DA2023.1107 for alterations and additions plus associated works to Office C and use as a child care centre at 4-8 Inman Road, Cromer | Response to request for information dated 6 February 2024

HERITAGE RESPONSE TO REQUEST FOR ADDITIONAL INFORMATION

REF NO. DA2023/1107 FOR CHANGE OF USE AND ALTERATIONS AND ADDITIONS TO "OFFICE C" FOR THE PURPOSE OF A CHILDCARE CENTRE AND LANDSCAPING AT 4-8 INMAN ROAD, CROMER

Figure 2. Demolition plan of the interiors of the heritage building approved under Mod 2022/0452.

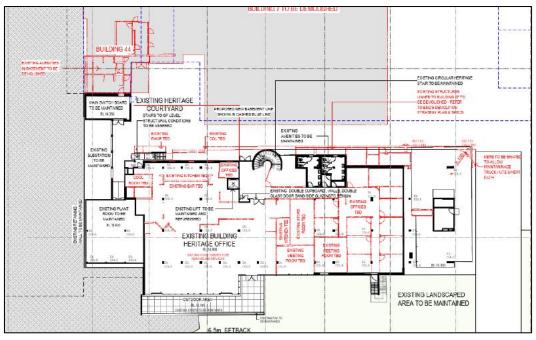
While some form of lightweight, reversible partitioning might be anticipated in an open plan environment such as this part of the complex, the drawings suggest a complex permanent subdivision of the space with the creation of hallways, offices, service areas and bathrooms. The extensive wet areas must raise complex servicing issues and would require invasive works for plumbing. Alternative approaches to that shown in the drawings might be possible, allowing for a genuinely reversible fit out of the space, more in tune with the management of the significance of such a complex.

The subject building had undergone extensive alterations and additions when it was used as an office building by Roche. The external glazing which was a significant feature of the Modernist building has been altered and is not original along the western façade. Prior to the development application DA 2019/1346 being approved, the interiors of the office building was divided using light weight partition walls to accommodate the various offices and meeting rooms and accommodated a kitchen and dining area. The open plan of the building was no longer extant and the internal finishes had been altered (see Figure 2).
